MDT CADD Update Notification

Subject: ADA Detail Sheet Truncated Dome Pattern Update

Date: 8/30/2020

DETECTABLE WARNING DEVICES

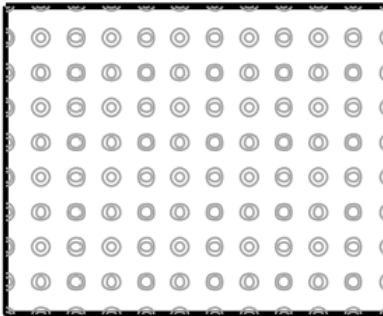
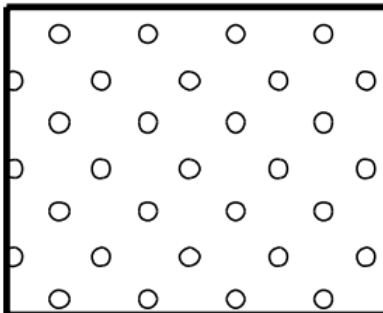
The CEL_RDDET_ADA cell has been updated to replace the existing pattern for ADA truncated dome panels, which does not reflect any of MDT's current circular patterns.

The CEL_RDDET_ADA cell has been updated so the pattern for the ADA truncated dome panels reflects MDT's CIR3 cell pattern.

For future ADA detail design, please utilize the CIR3 pattern to hatch the proposed truncated dome areas. This will match the updated ADA detail sheet.

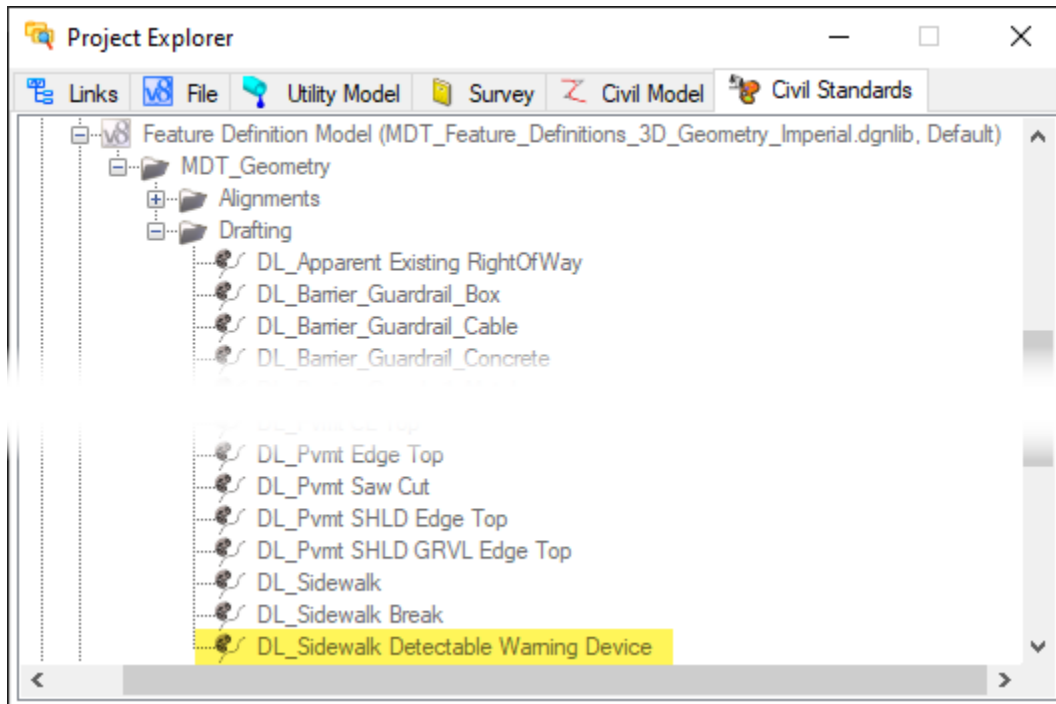
In addition, a new feature definition has been added to the library. When laying out truncated dome panel areas, the DL_Sidewalk Detectable Warning Device feature definition is available.
